APPENDIX B

Responses to NRC Requests for Additional Information (RAI) Air Quality

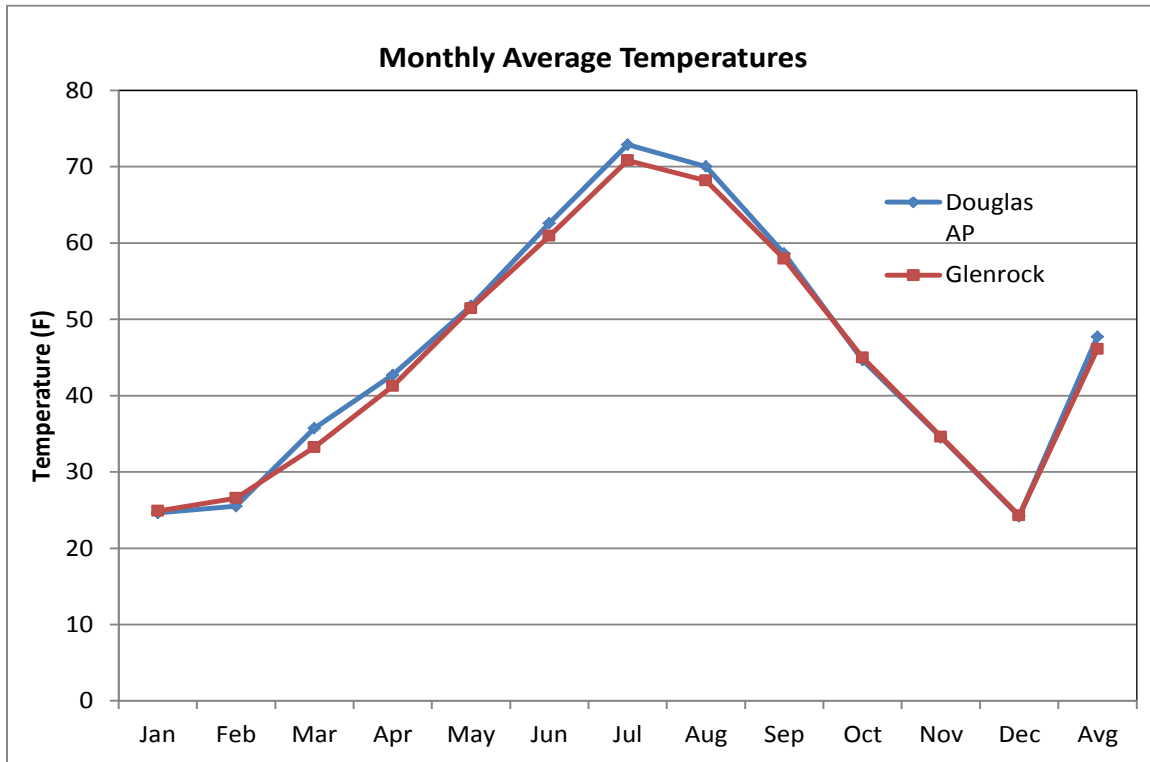
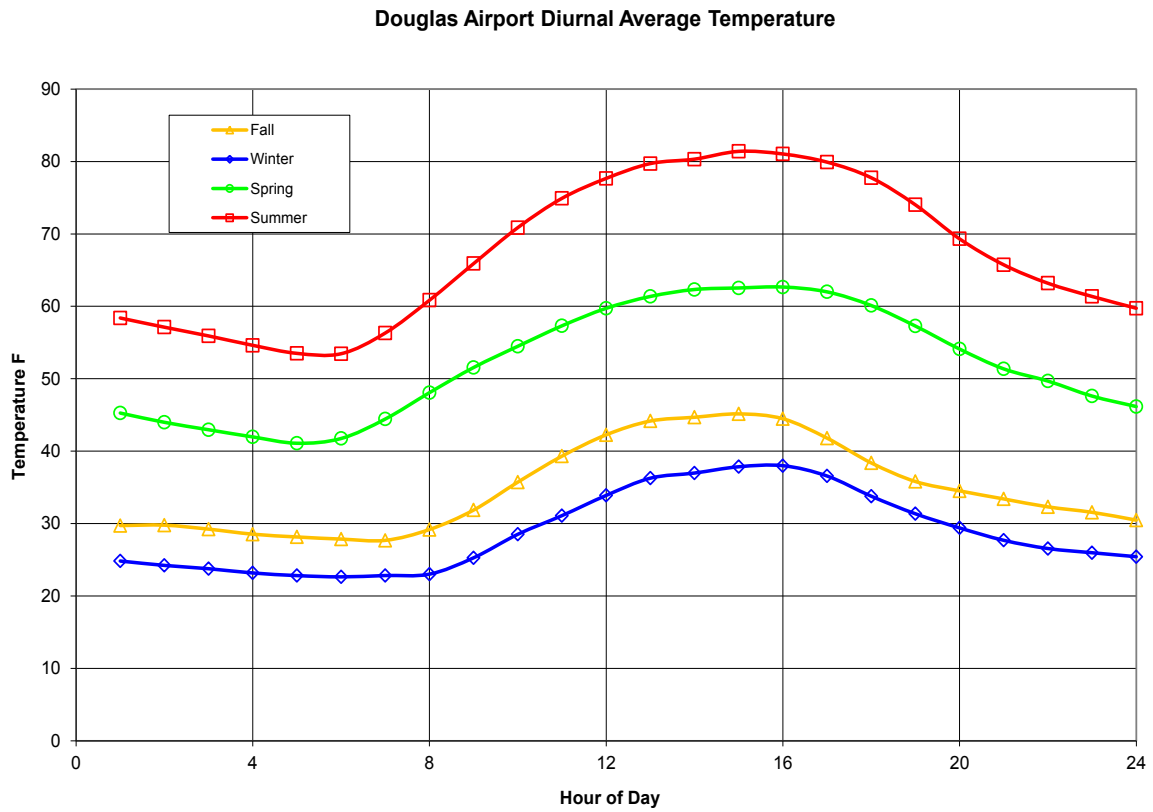
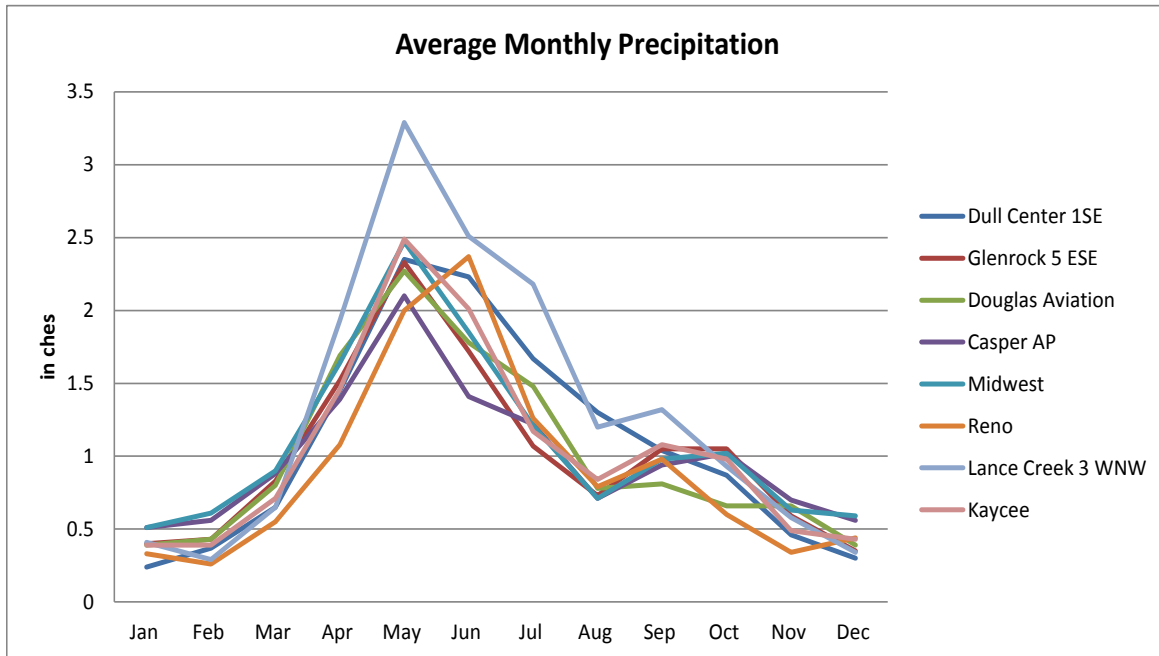
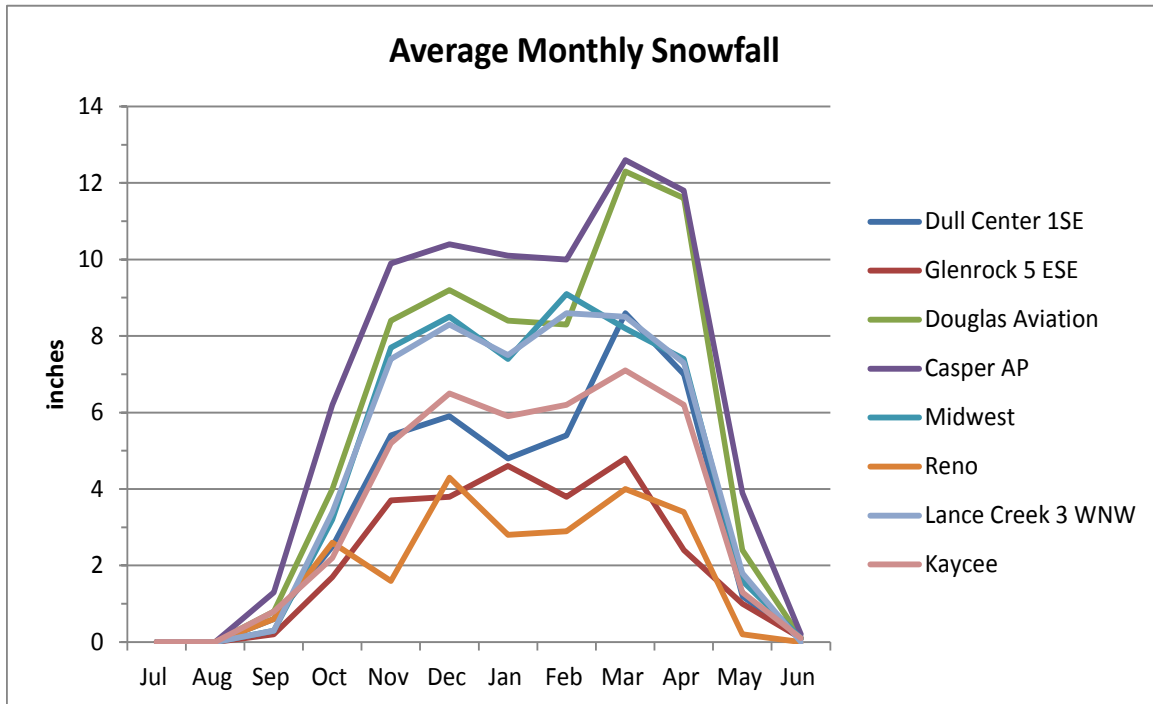
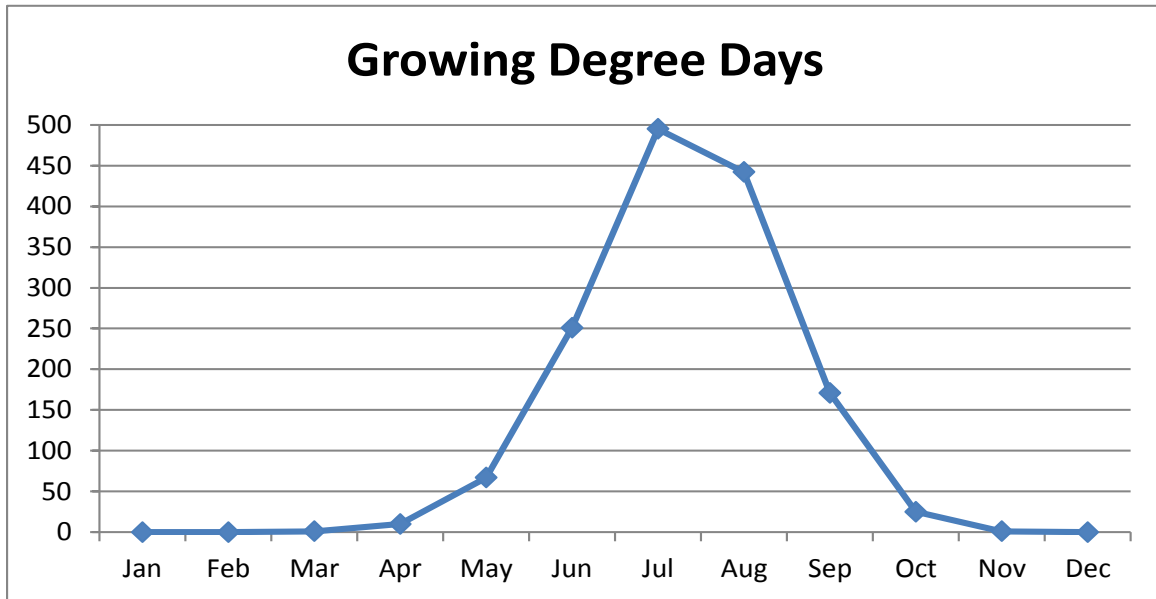
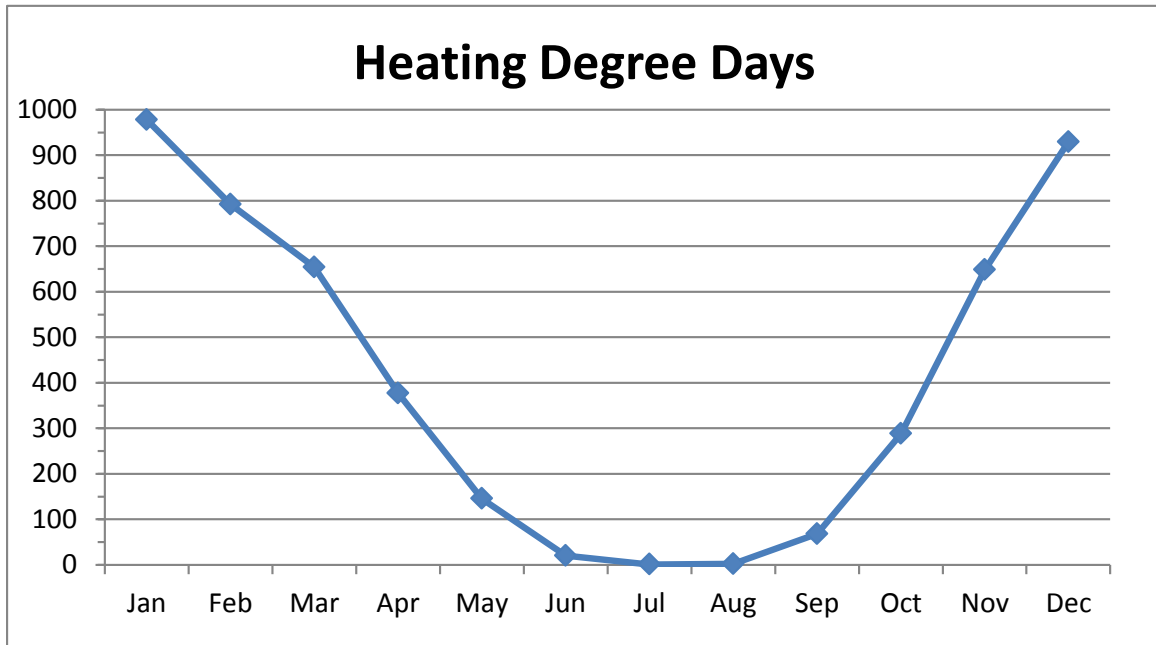
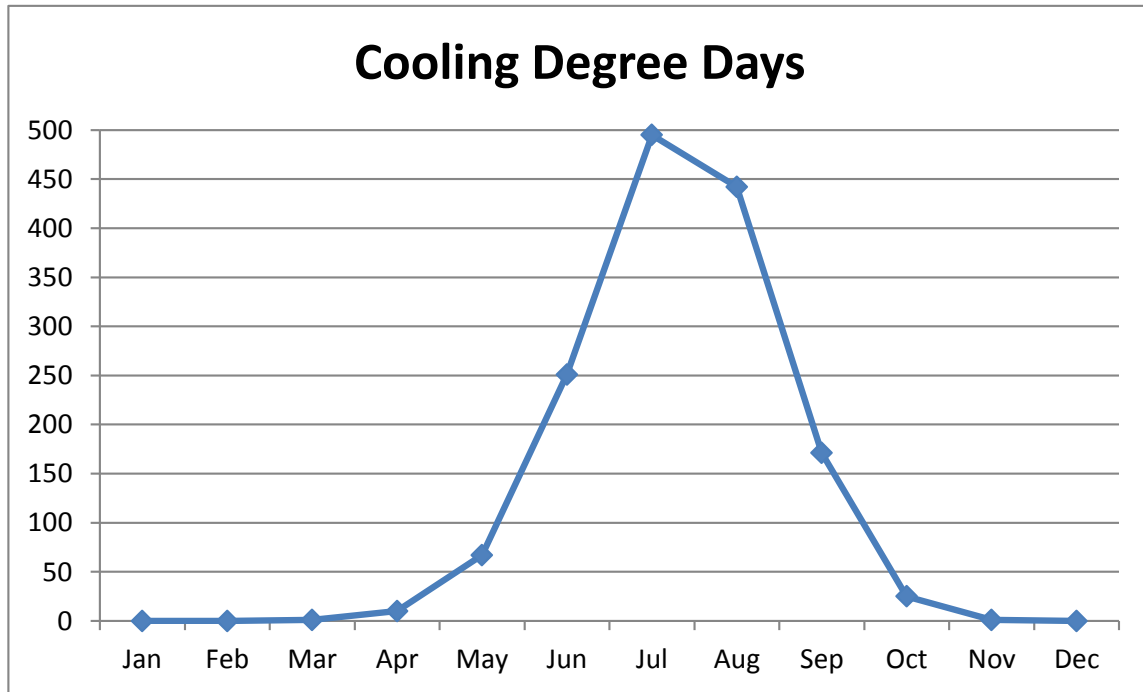
- A. Please confirm that the 2005 and 2007 data described in Section 3.6.1 are the best available data to characterize the meteorological conditions at the Ludeman Project or update the data with the most current information. Also, please include a map identifying the locations of monitoring stations relative to the Project area.*
- B. Newcastle is listed in Table 3.6-1 of the ER as one of the meteorological stations included in the climate-change analysis. Please address the absence of data for Newcastle in the text and subsequent figures.*

The period of record presented in the ER was based on available data at the time that it was originally developed. While the long-term regional climatic conditions tend to remain relatively stable over time, the tables and figures below have been revised to reflect the most recent meteorological data available.
